Re: Recall No.04V-063, Supplemental Information

2003 VULCAN® 1600 CLASSIC (VN1600-A1/L),
2004 VULCAN® 1600 CLASSIC (VN1600-A2/L)

MC 04-05

MUFFLER BRACKET CRACKING

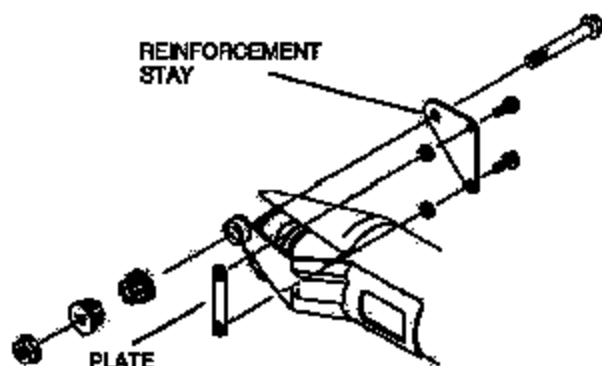
- Check if cracking is present at the upper or lower muffler brackets.

- If there are signs of cracking, replace the muffler. The muffler brackets on the replacement muffler have already been reinforced and the reinforcement kit is not required.

Lower Muffler Bracket

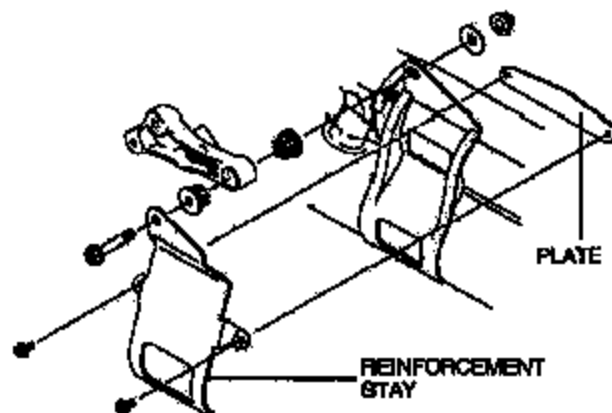
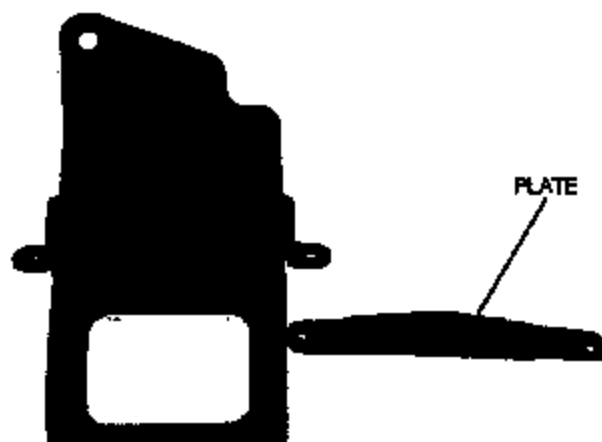
- Place the reinforcement stays onto the lower muffler bracket and tighten the bolts temporarily.

- Place the reinforcement stay on the upper muffler bracket. Tighten the rear bolt on the reinforcement stay securely and tighten the front bolt temporarily.

- The plate which tightens over the bracket is angled on one edge. Place the angled edge up as shown.

For Installation of the Reinforcement Kit

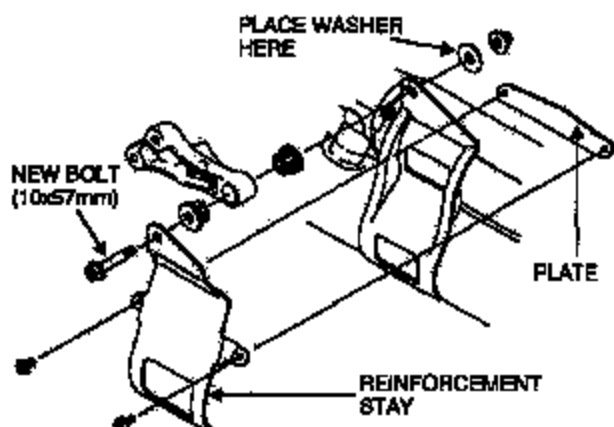
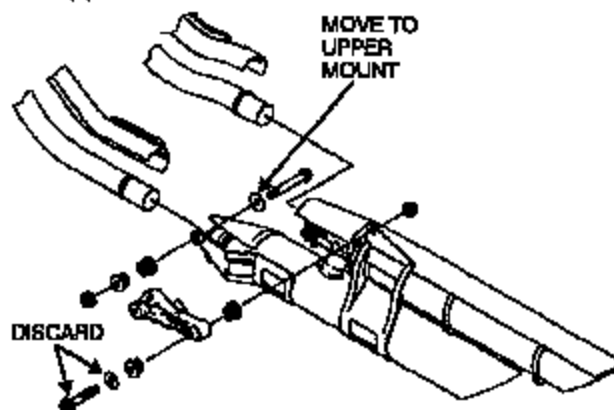
- When installing the reinforcement kit, remove the upper mounting bolt (10x54mm) and the washer (10.5x26x2.3mm) from the inside of the upper muffler bracket and discard.
- Replace the upper muffler bracket bolt (10x64mm) with the correct size (10x57mm) supplied in the kit.

- Move washer (10.5x30x2.3mm) from the lower muffler bracket to the upper bracket underneath the nut as shown.

For Installation of New Muffler

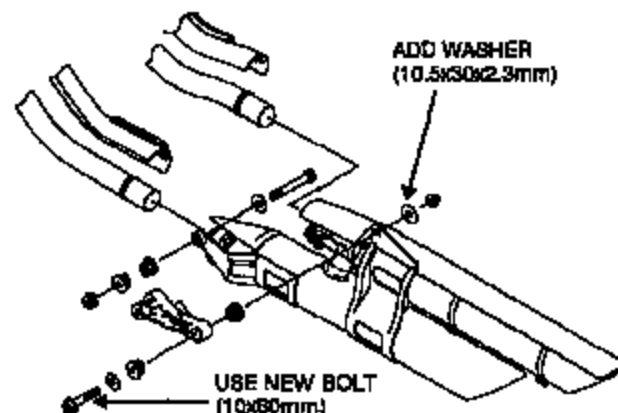
- When installing a new muffler, replace the upper bolt with the longer bolt (10x80mm) and a washer (10.5x30x2.3mm) underneath the upper muffler bracket nut.

Repair Verification

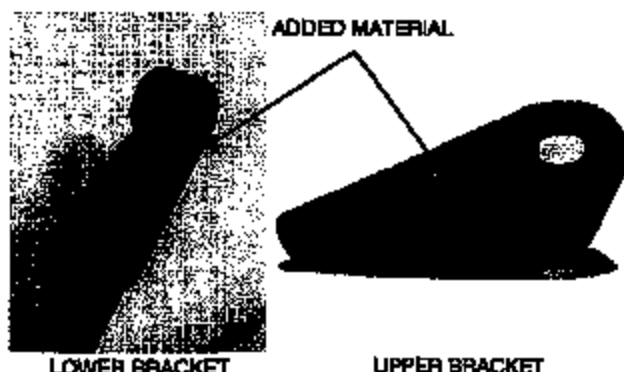
The presence of the muffler bracket reinforcement kit, or the additional material welded to the muffler brackets will serve as repair verification.

- o On the replacement muffler, additional material has been welded onto the existing brackets the locations shown below. The additional material doubles the existing bracket thickness.
